## **Coupling force control – ECE R13**

### **(Proposal from the Danish delegation)**

Diagram 1

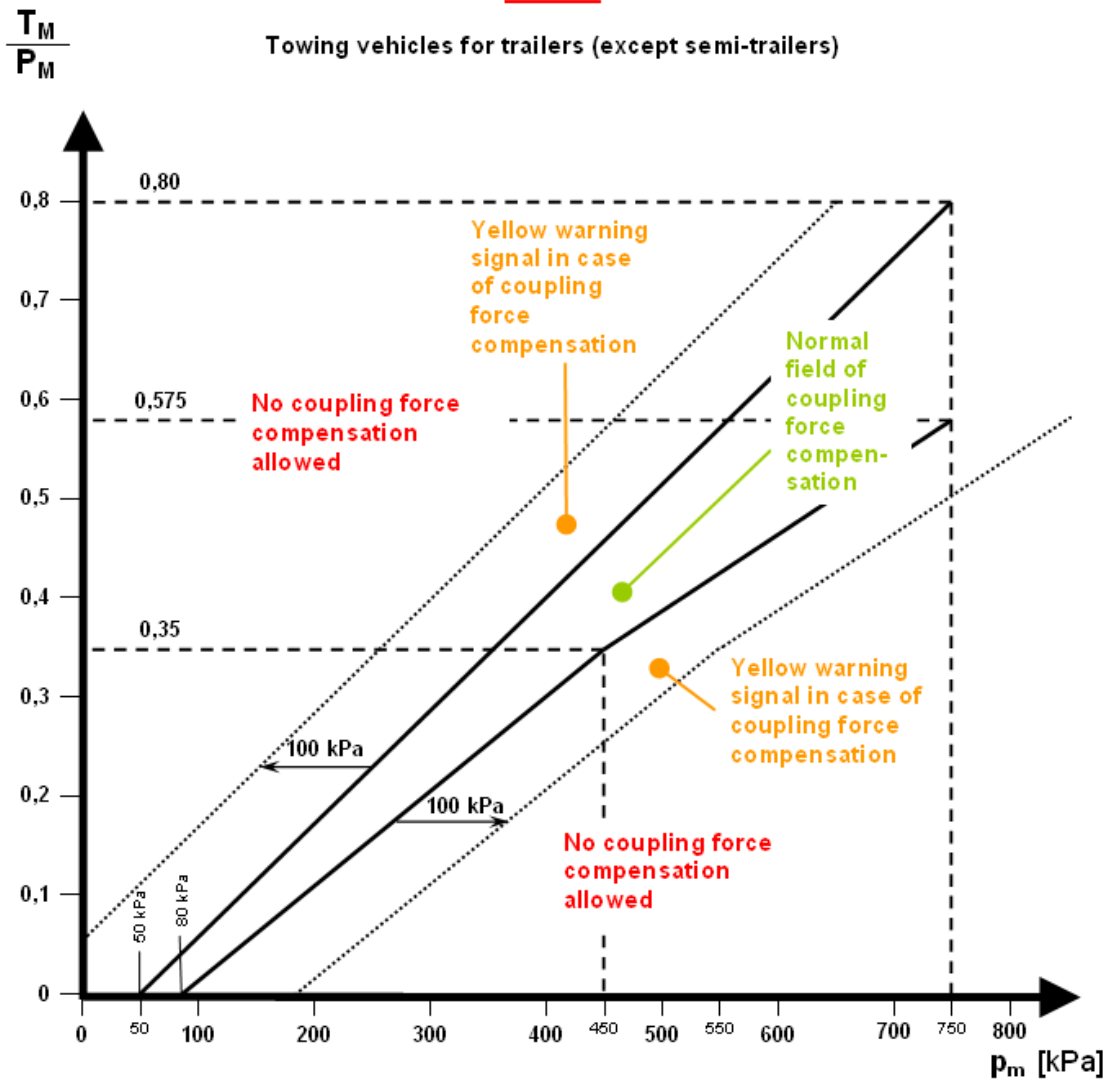
**5.2.1.28.5. The coupling force control system shall tend to minimise the coupling force. Max. allowed compensation by the coupling force control system is 100kPa below the lower limit of the compatibility band and 100kPa above the upper limit of the compatibility band as specified in Annex 10. If this compensation causes the operating point to lie outside the compatibility band as specified in Annex 10 for the motor vehicle the yellow warning signal specified in paragraph 5.2.1.29.1.2 shall be activated. After recoupling no compensation is allowed before the coupling force control system has registered a difference between the braking rates of the vehicles in the combination.**
